4.0 COMPARISON PLANS

14-19 Tottenham Mews, London W1T 4AA **17**

6.1 PRE-PLANNING - MEETING FEEDBACK

4.2 GROUND FLOOR

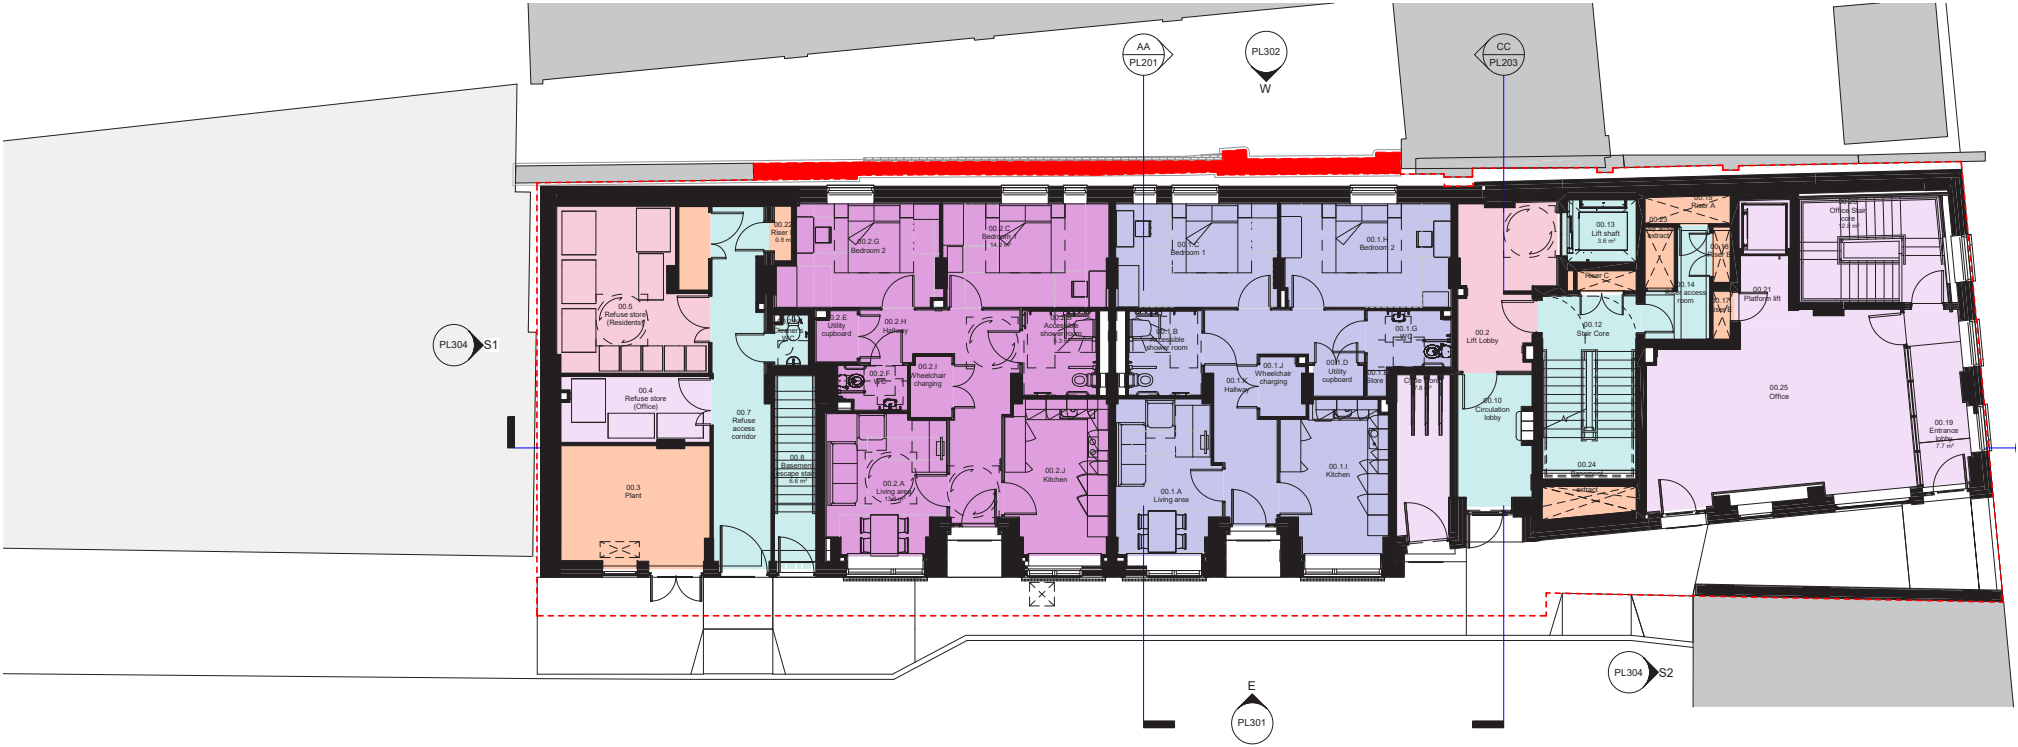
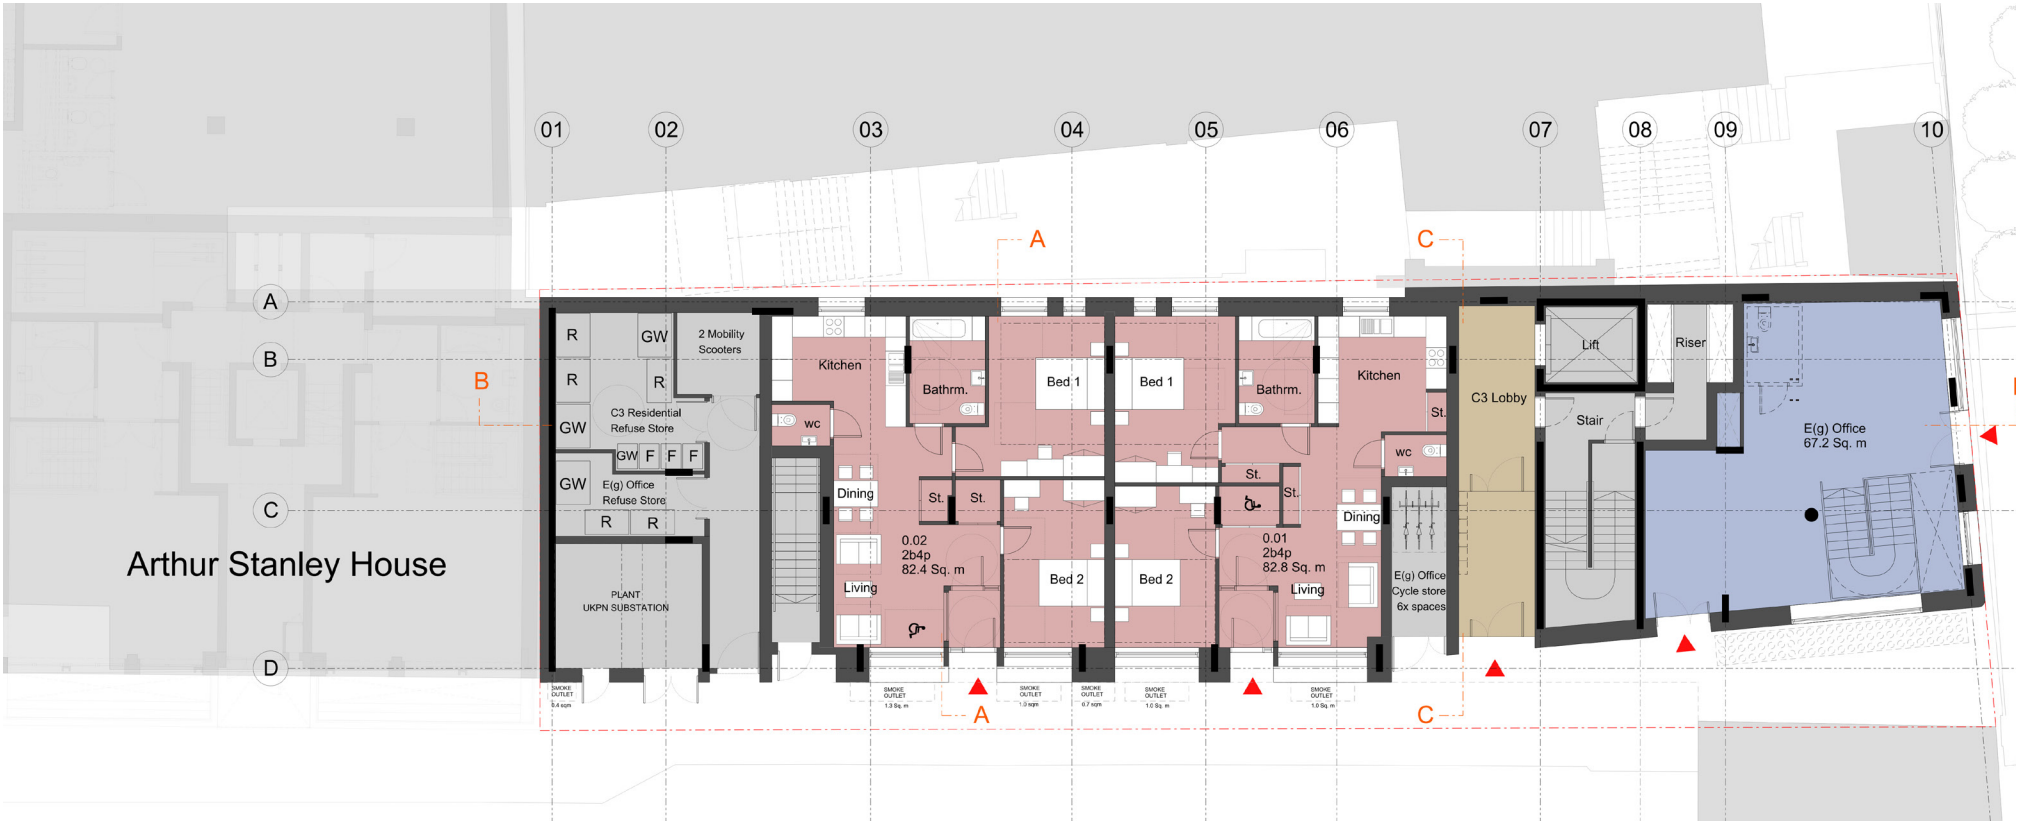
GF Refuse store/plant (to replace sub station).

- Can these be switched? Does refuse store need to open directly onto outdoors (we are seeing this in many other schemes elsewhere)? Easier journey for residents, less conflict with mobility scooter storage, less drag distance etc.

- You asked if the plant room to the southern corner could be swapped with the residential bin store to provide a more useable bin store for the residents. I confirmed that this had been looked at, but the issue was that the corridor leading to the rear room was not wide enough to accommodate some of the plant equipment if it needed to be replaced, hence why we placed the plant room at the front of the building with the double doors. I said we could look at this again now that we had a better idea of the exact size of plant which was to be accommodated and whether the corridor could accommodate its replacement.
